SUBJECT: Bulletin No. 1 to the Plans and Special Provisions for the Construction of Santa Ana River Interceptor (SARI) Relocation – Yorba Linda Spur – within Facility No. E01, La Palma Avenue and Santa Ana River Trail from SAVI Ranch Development to 780 Feet East of Via Lomas De Yorba East.

The bidder's attention is directed to the following changes to the Plans and Special Provisions, and the responses to questions:

Attachment D
Drawing Sheet G-5

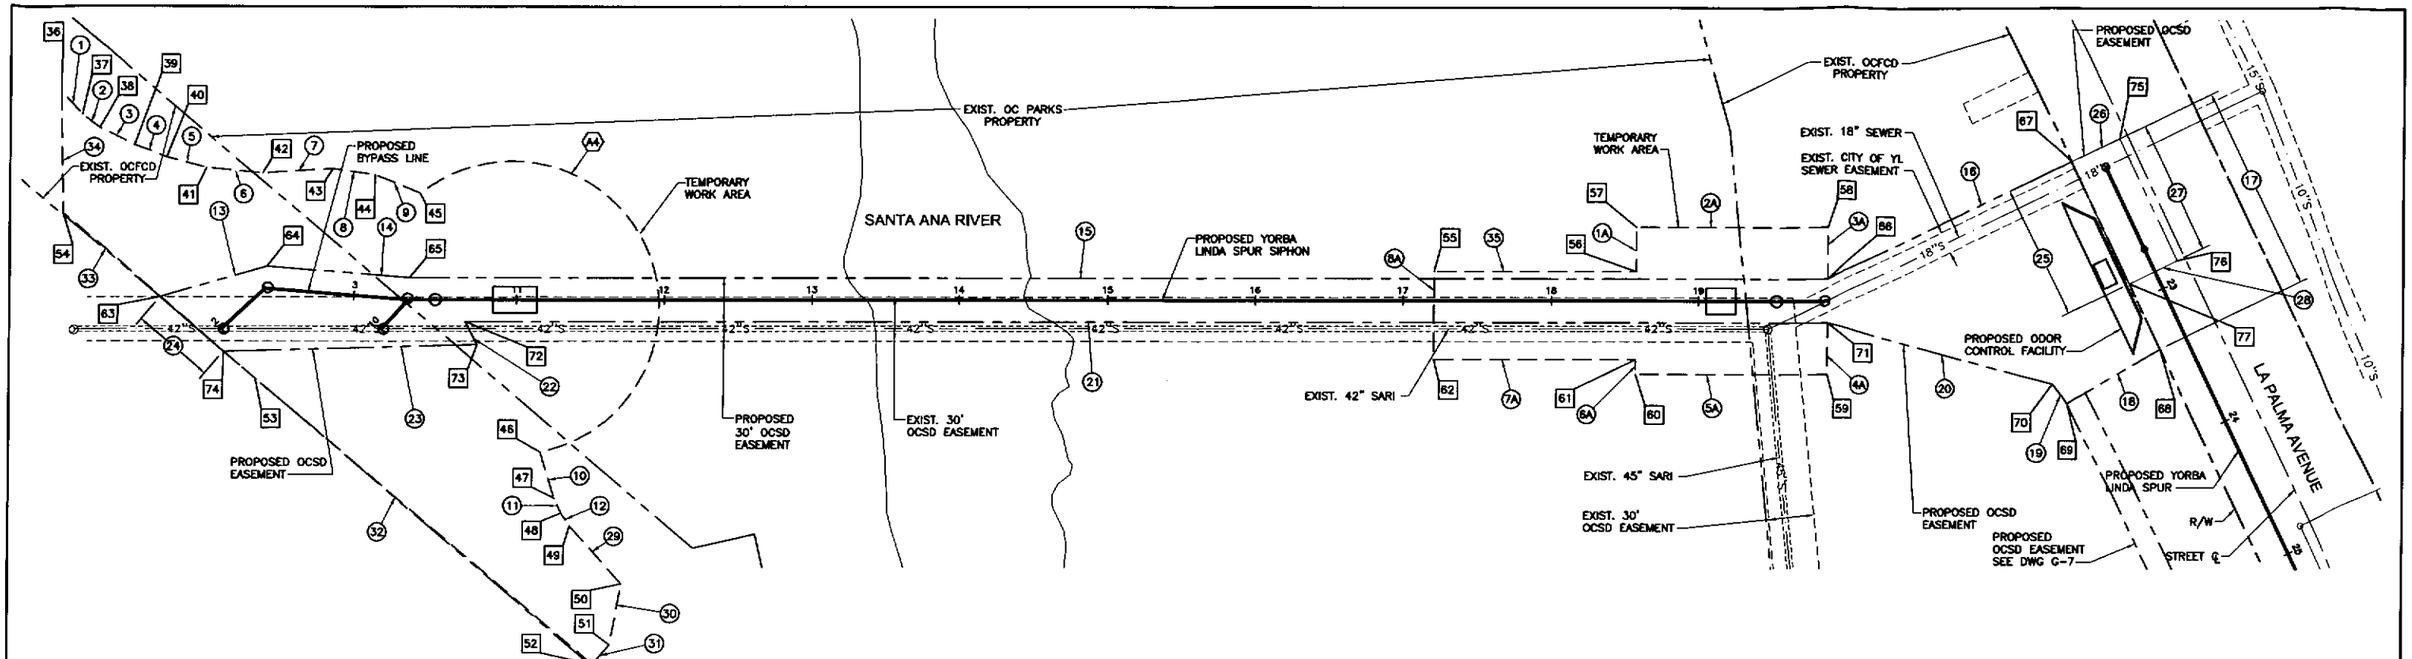
28. VOLUME II – PROPOSED EASEMENTS AND TEMPORARY WORK AREA HORIZONTAL CONTROL PLAN, **REPLACE** DRAWING SHEET G-5 with Attachment D.

Attachment E
Drawing Sheet C-15

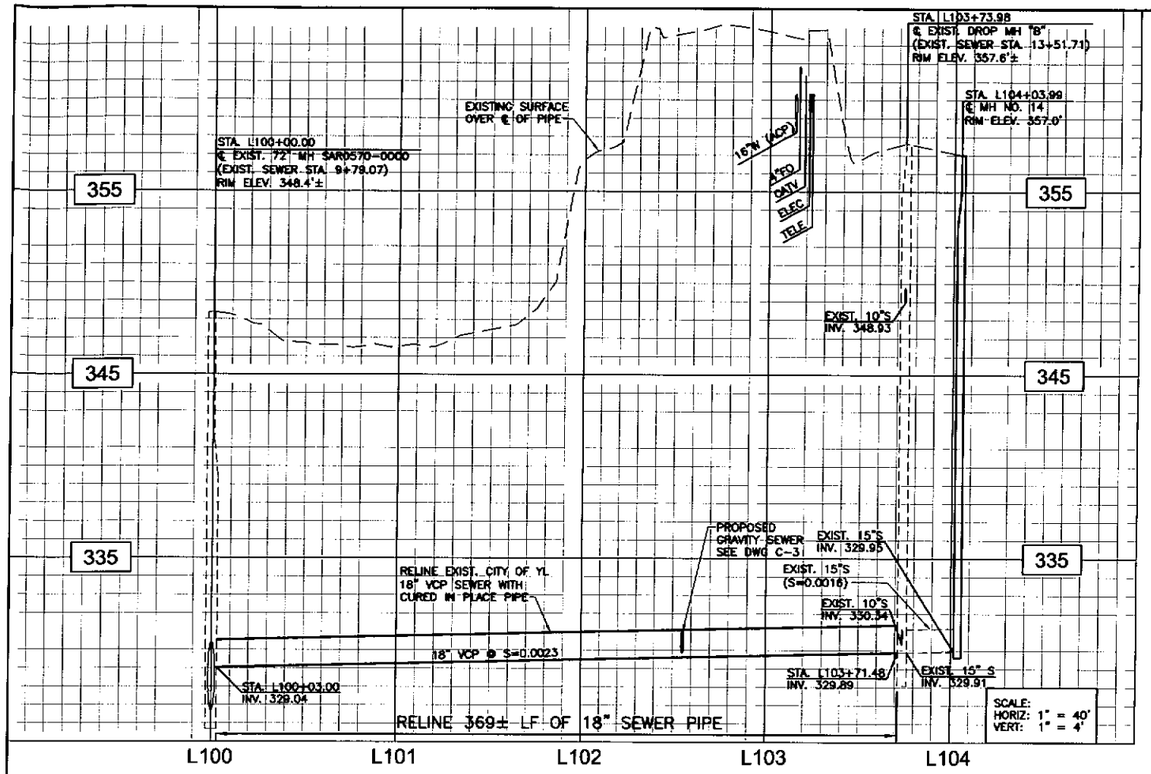
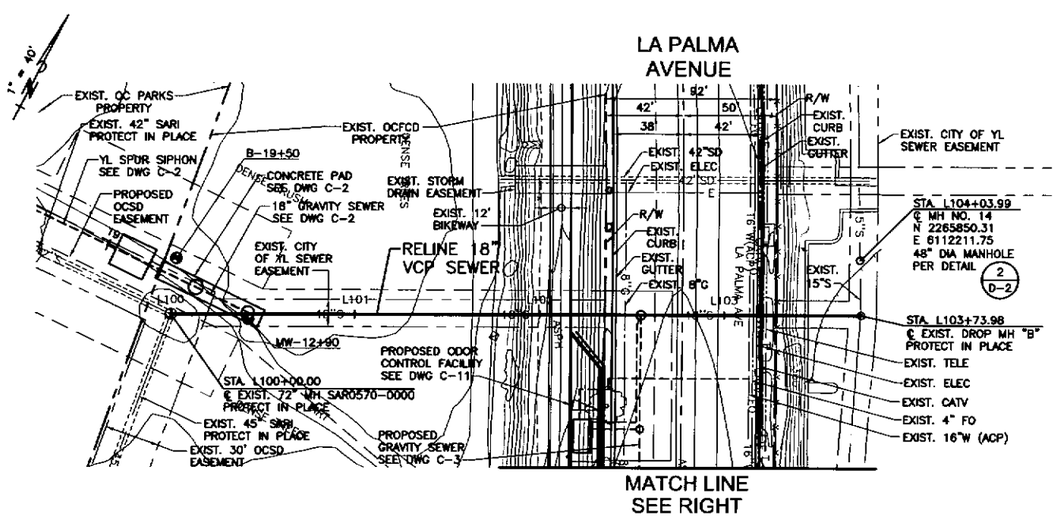
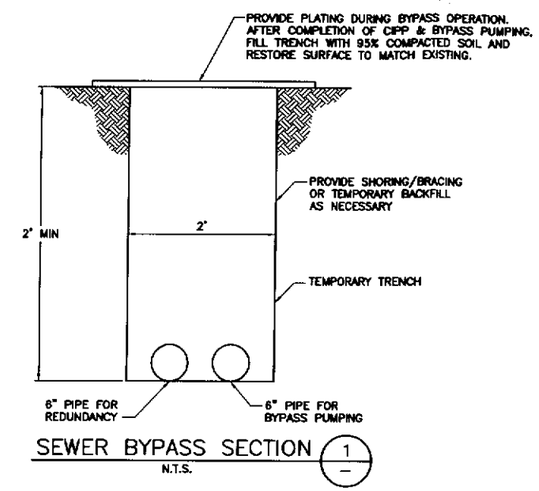
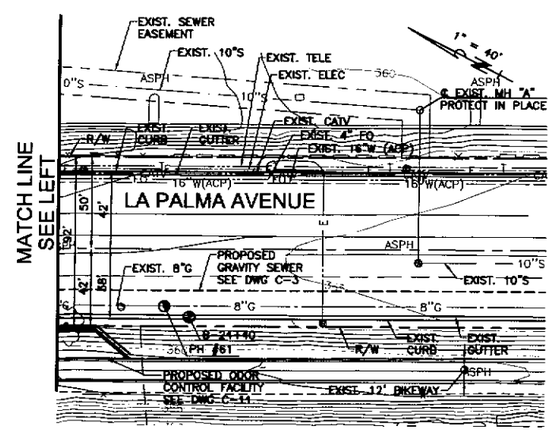
29. VOLUME II – SANTA ANA RIVER CROSSING PLAN AND PROFILE CIPP REHABILITATION, **REPLACE** DRAWING SHEET C-15 with Attachment E.

51. QUESTION: Where are MH SAR 0570 and MH L103+73.98 shown?

ANSWER: Refer to VOLUME II – DRAWING SHEET C-15.
